Access Compliance Report

Public Rights-of-Way

(Curb Ramps)

Intersection ID: N/A	Main Street: S_CALDWELL_ST	Cross Street: E_MARTIN_LUTHER_KING_JR_BV	Location: NE
ADA ID: F2E4EEC1954B	Ramp Type: Para	Initial Pass/Fail: Fail	Overall Compliance: No
Severity Score: 26.25			
Codes/Mitigation Info/Possible Solution		Field Measurements/Component Compliance

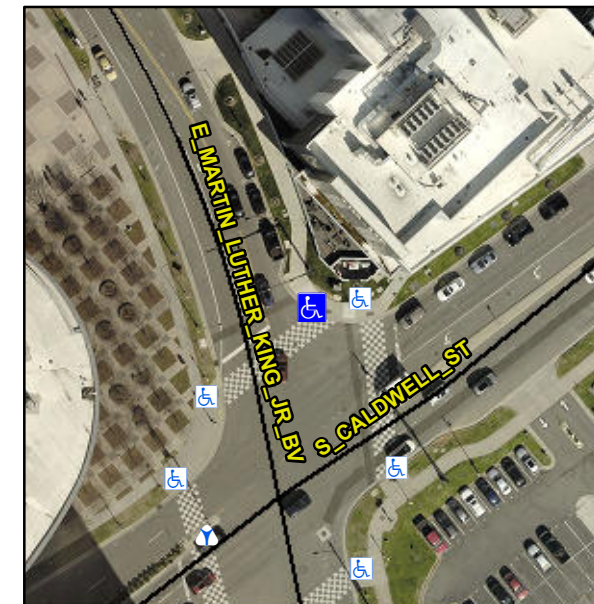
R304.3.2, R304.5.3

Compliance	Description	Data	Compliance	Description	Data
N/A	Ramp Length LT (in)	67.0	N/A	Ramp Length RT (in)	56.0
Yes	Ramp Width LT (in)	94.0	Yes	Ramp Width RT (in)	94.0
No	Ramp Slope LT (%)	12.0	Yes	Ramp Slope RT (%)	6.0
No	Ramp XSlope LT (%)	2.1	Yes	Ramp XSlope RT (%)	1.6
N/A	Landing Length (in)	N/A	N/A	DWS Provided?	N/A
N/A	Landing Width (in)	N/A	N/A	DWS Contrast?	N/A
N/A	Landing Slope (%)	N/A	N/A	DWS Length (in)	N/A
N/A	Landing X Slope (%)	N/A	N/A	DWS Full Width?	N/A
N/A	Landing Curb? (Y/N)	N/A	N/A	DWS Offset (in)	N/A
N/A	Shared Landing?	N/A			
N/A	Gutter Ponding?	N/A	N/A	Gutter Slope (%)	N/A
N/A	Gutter Lip Ht (in)	N/A	N/A	Gutter X Slope (%)	N/A
N/A	Painted X Walk1?	Yes	N/A	Painted X Walk2?	N/A
	X Walk 1 Direction	To SW		X Walk 2 Direction	N/A
N/A	X Walk 1 Width (in)	144.0	N/A	X Walk 2 Width (in)	N/A
	X Walk 1 Slope (%)	0.7		X Walk 2 Slope (%)	N/A
	X Walk 1 X Slope (%)	2.9		X Walk 2 X Slope (%)	N/A
N/A	Ramp inside XWalk1?	Yes	N/A	Ramp inside XWalk2?	N/A

Remove & Replace Entire Ramp.
